PROPOSED OFFICE BUILDING

111 MAPLEWOOD AVENUE
PORTSMOUTH, NEW HAMPSHIRE

PROJECT NO: K-0076-019

**TAC SUBMISSION
COMPLETE SET 30 SHEETS**

C-102.2

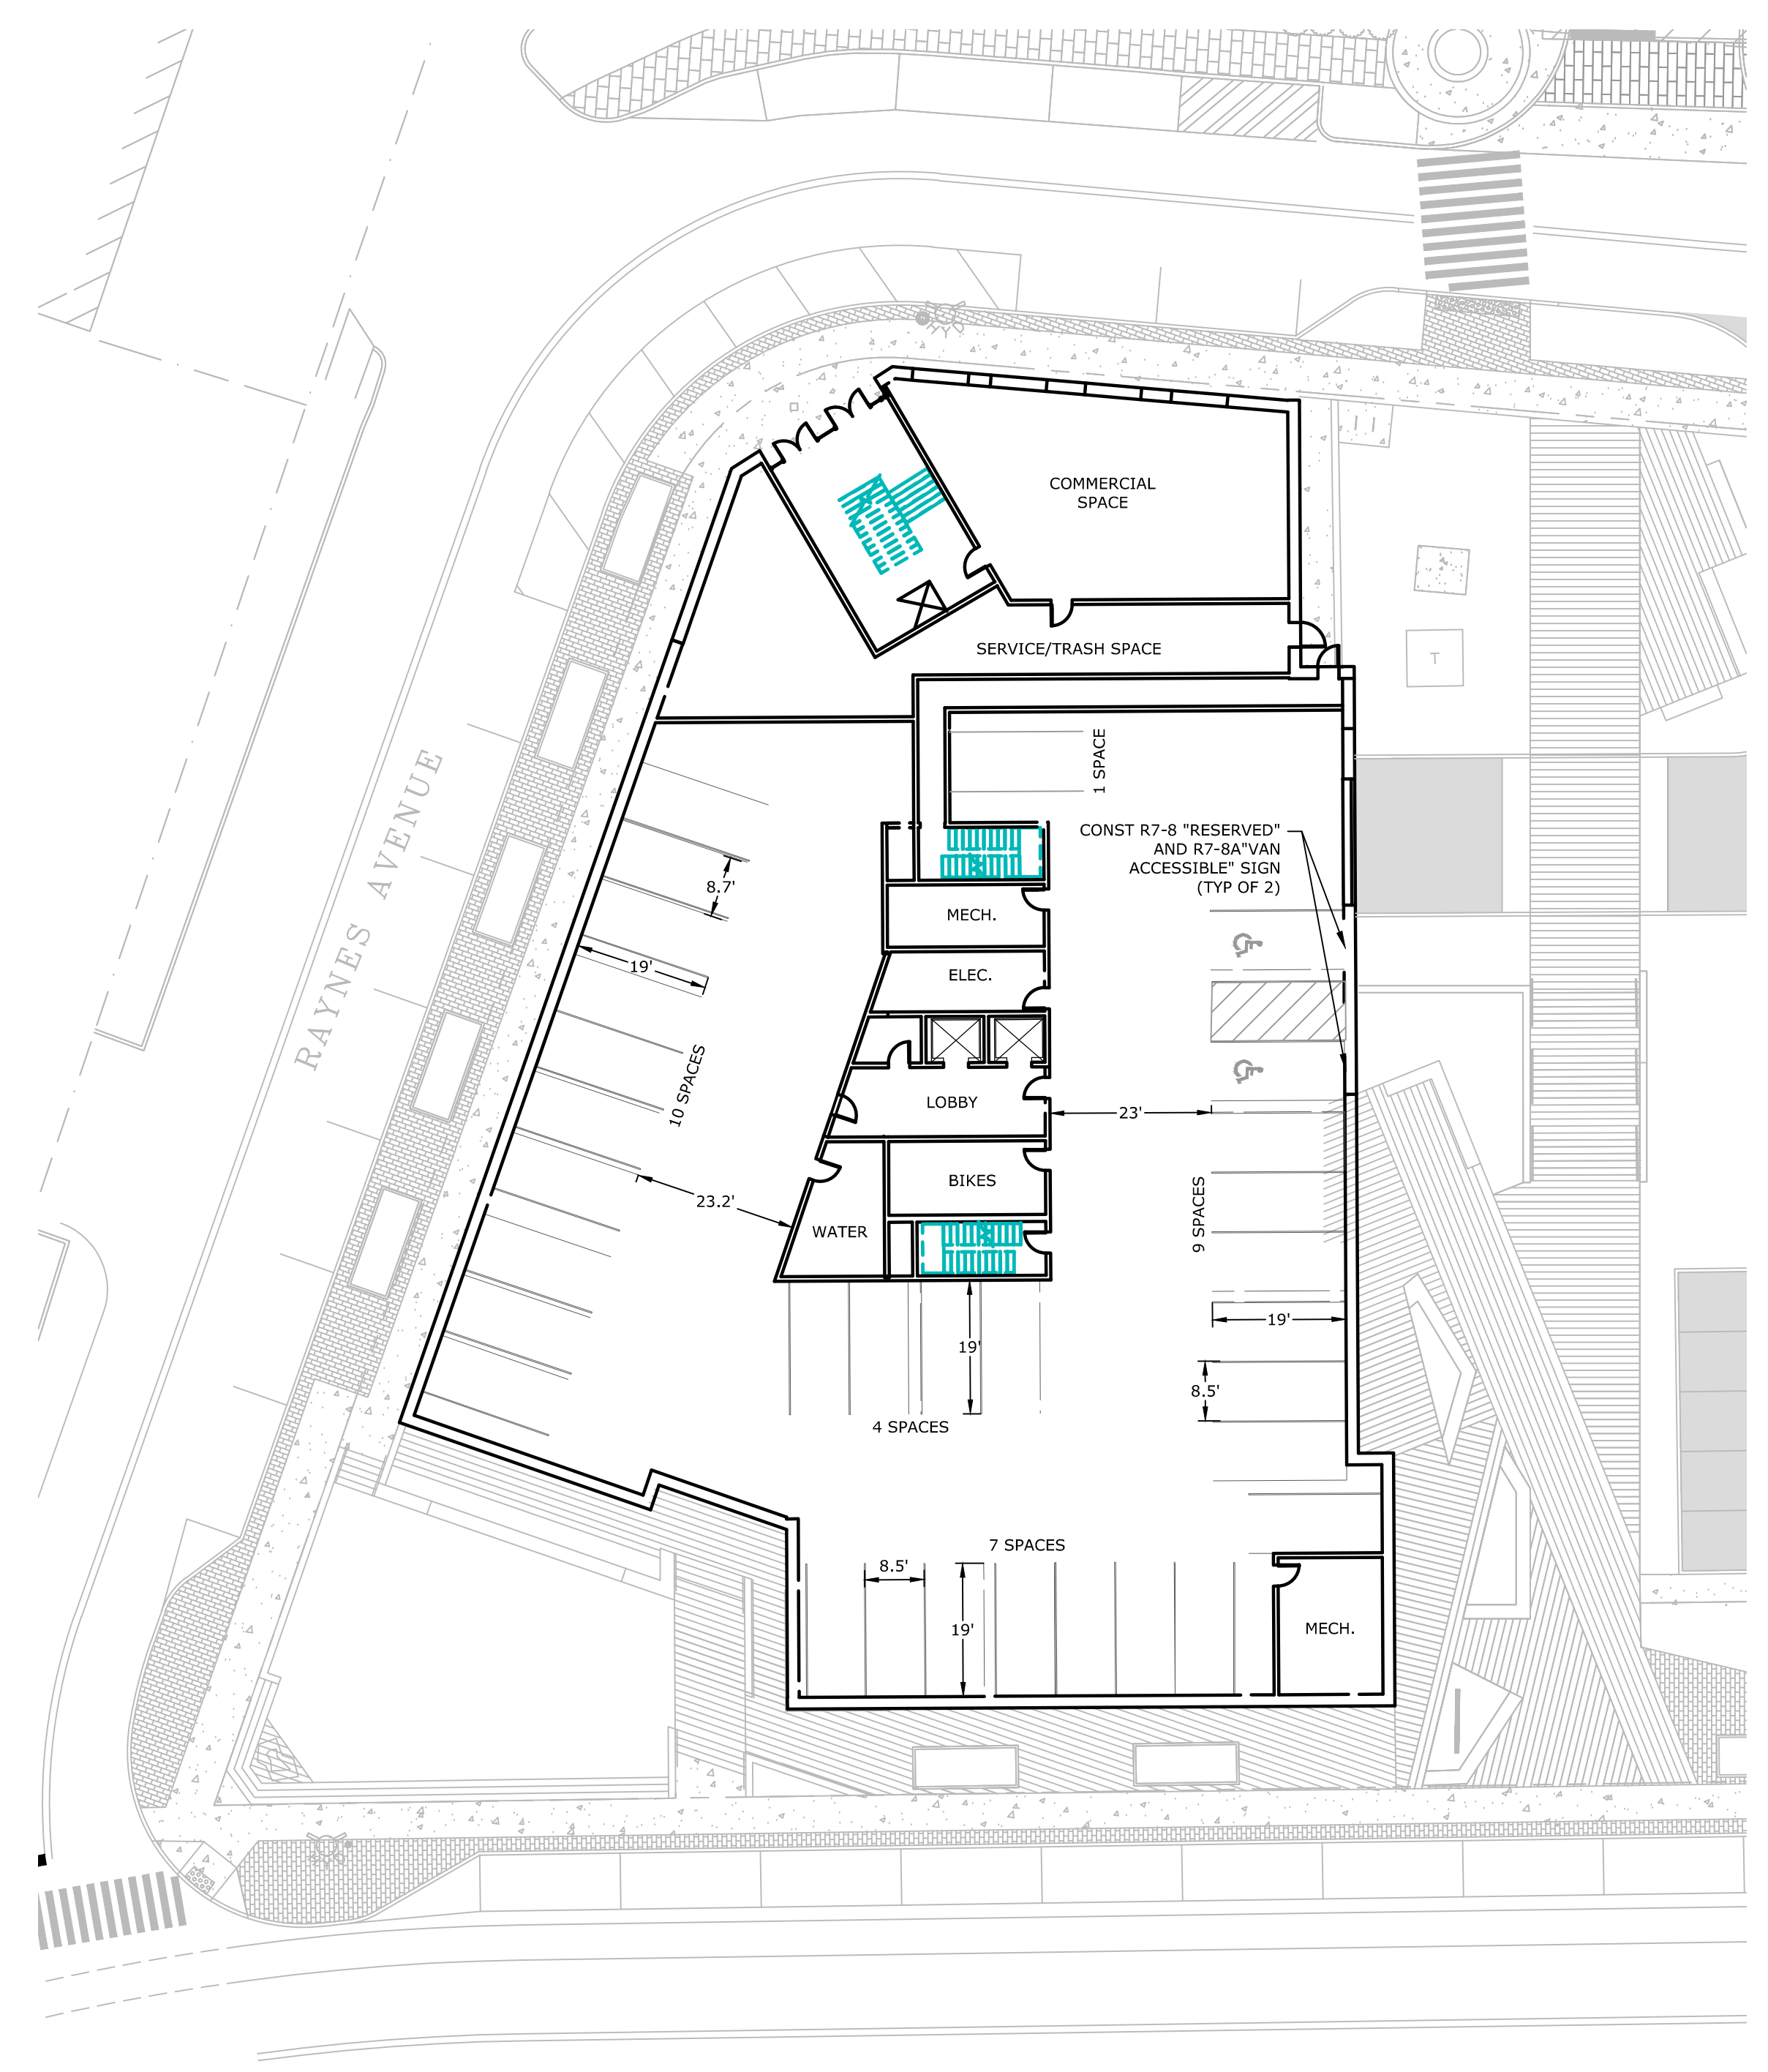
5	Appropriate contribution for City Sewer construction project may be required, coordinate with DPW	As per Note #21 on the Site Plan, the value of a fair share contribution towards off-site public improvement projects shall be agreed upon between the Applicant and City prior to final approvals.	C-102.1 & C-102.2
6	Is there internal bypass for high flows in the stormwater unit?	Confirmed, there is an internal bypass in the stormwater unit. It should also be noted these revised plans include a different stormwater unit than previously shown due elevation constraints driven by utilities in the roadway. A design memorandum prepared by Contech, the stormwater unit manufacturer, has been included in the latest drainage analysis.	C-103.1 & Drainage Analysis
7	Add additional CB drains in Vaughan St/Raynes Ave as determined to be needed by DPW to maintain a crowned road section.	Note #22 has been added to the Site Plan indicating that the Applicant shall work with the City to confirm project scope and timing as it relates to the City's Complete Streets Improvement Project that is being designed by the City's consultant.	C-102.1 & C-102.2

11	Review alignment of lights along Maplewood Avenue to make sure they are at a consistent distance off the curb line and check for conflicts with car door swing.	The light fixtures along Maplewood Avenue have been revised to be along the back of curb and have been aligned to avoid conflicts with door swings.	C-102.1 & L-101
12	Confirm whether mechanical equipment such as a generator will be installed on the roof or ground surface. If on the ground surface, the equipment shall be shown on the Site Plan and shall meet any applicable setbacks required by building code.	At this time, it is anticipated that mechanical equipment will be housed on the roof and will be screened.	C-102.3
14	Building is classified as 5 stories per building code. Might need an elevator lobby in the basement level.	The Basement Level Plan has been revised include an elevator lobby.	C-102.3
17	Will SOE (if required) will have impacts in ROW? If so, a the applicant shall provide the design to DPW for review prior to construction.	Note 20 has been added to the Site Plan indicating that a Temporary Support of Excavation (SOE) Plan, if necessary, shall be prepared by the applicant's contractor prior to construction. If the SOE design impacts the City's Right of Way, the SOE Plan shall be included in the Construction Management and Mitigation Plan (CMMP) for review and approval by the City. If licenses are required for the SOE, the applicant will be required to obtain these from the City prior to construction.	C-102.1
